**U.S. DEPARTMENT OF ENERGY  
BROOKHAVEN NATIONAL LABORATORY  
CERCLIS Number NY7890008975**

**FINAL OPERABLE UNIT III  
EXPLANATION OF SIGNIFICANT DIFFERENCES  
FOR  
AREA OF CONCERN 32  
BUILDING 452 FREON-11 SOURCE AREA AND  
GROUNDWATER PLUME**

**May 24, 2012**

**Figure 1. Location of Building 452 Freon-11 Groundwater Plume During 2011, Monitoring Wells and Extraction Wells.**

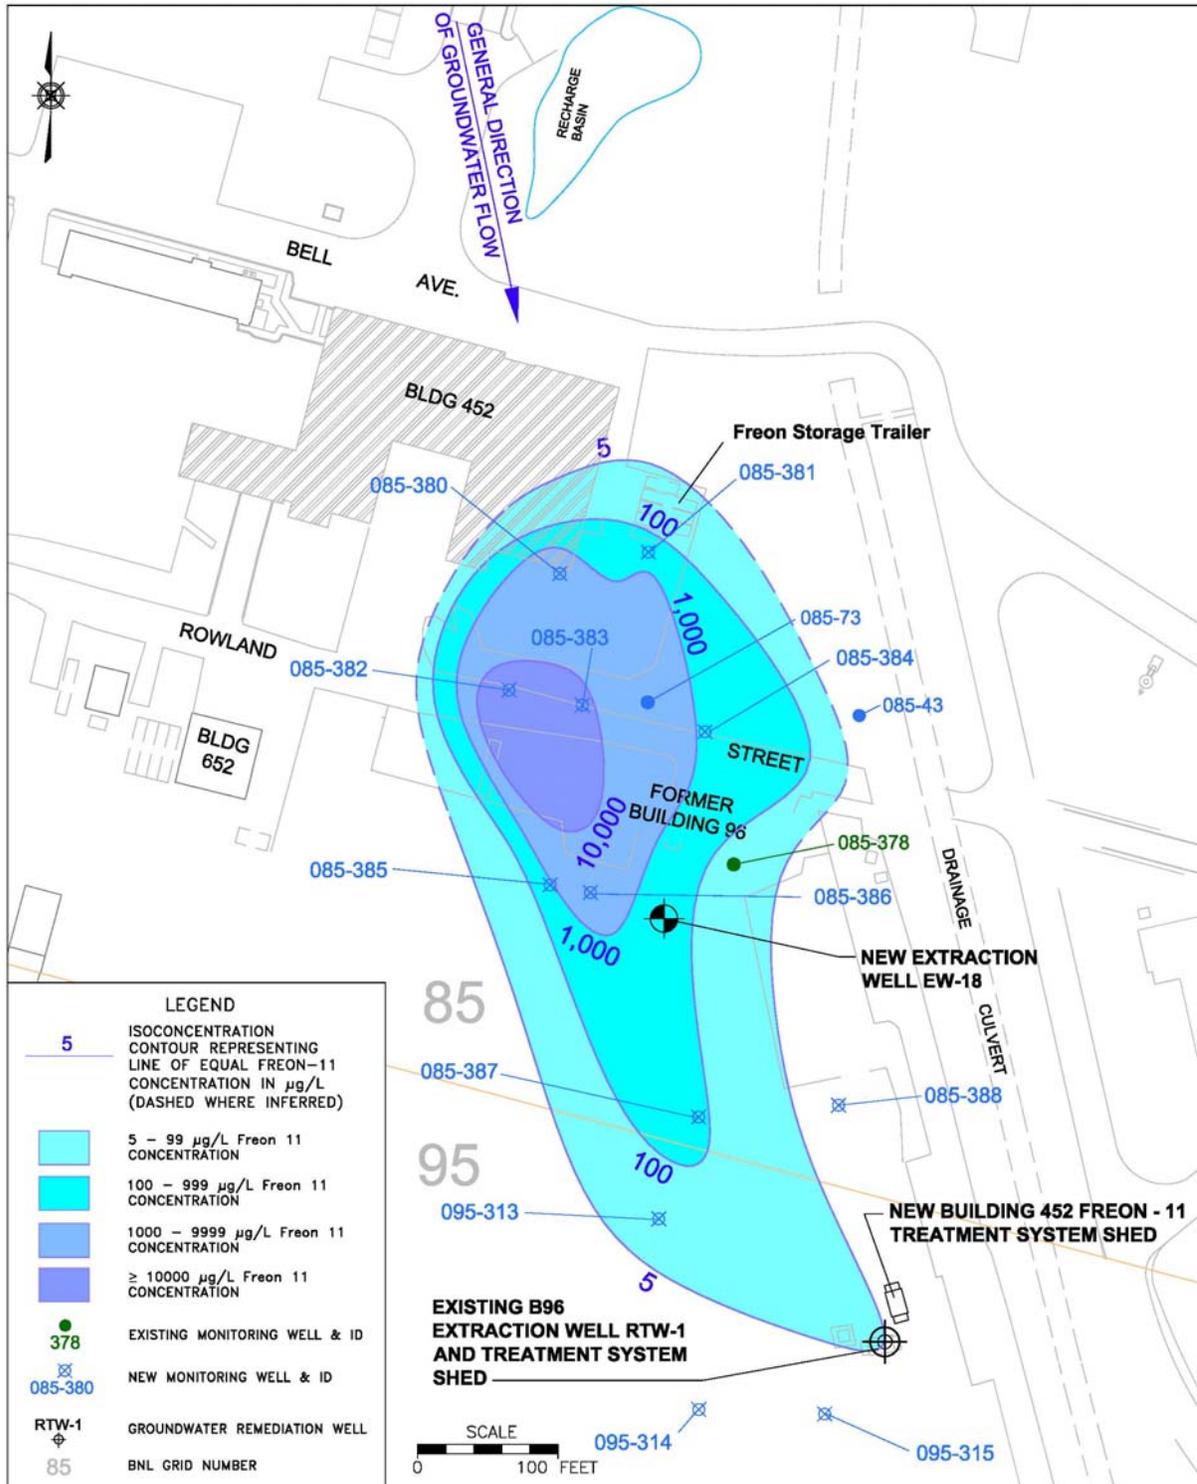
Due to the high levels of Freon-11 detected in groundwater and the extent of the plume, active remediation of the plume is required to ensure that the OU III ROD cleanup objectives are met. To achieve the cleanup objectives, operation of newly installed extraction well EW-18 and the use of existing Building 96 Groundwater Treatment System extraction well RTW-1 will be needed to maintain hydraulic control and remediate the plume (DOE, 2012a). The high concentration segments of the Freon-11 plume will be captured by extraction well EW-18, while the lower concentration, downgradient segments of the plume will be captured by RTW-1. The treatment system began start-up testing in March 2012. Groundwater from extraction well EW-18 is treated using an air stripper tray system located in a new treatment building located adjacent to the existing treatment building for RTW-1 (**Figure 1**). Groundwater from extraction well RTW-1 is also treated using a tray air stripper system. The treated water from both groundwater treatment systems is discharged to a nearby stormwater culvert which leads to BNL recharge basin HS, where the water is recharged back into the Upper Glacial aquifer (**Figure 2**). The discharge from the Building 96 treatment system is regulated under a NYSDEC State Pollutant Discharge Elimination System (SPDES) equivalency permit. This permit has been modified to include Freon-11 as a discharge monitoring parameter (NYSDEC, 2012a). The discharge from the new Freon-11 treatment system is regulated under a separate SPDES equivalency permit (NYSDEC, 2012a). Review of the potential atmospheric emissions following the New York State air emissions modeling (DAR-1) process shows that the release of Freon-11 from this system will not pose short-term or long-term impacts (DOE, 2012b; DOE, 2012c). The atmospheric discharges are regulated under a NYSDEC air equivalency permit. In addition to operating the groundwater remediation system, DOE will evaluate the extent of residual Freon-11 contamination in the vadose (unsaturated) zone soils above the water table in the Building 452 source area, as well as continue to monitor the wells immediately downgradient of the source area. This ESD will include source controls/remediation, if they are deemed necessary to meet the cleanup objectives.
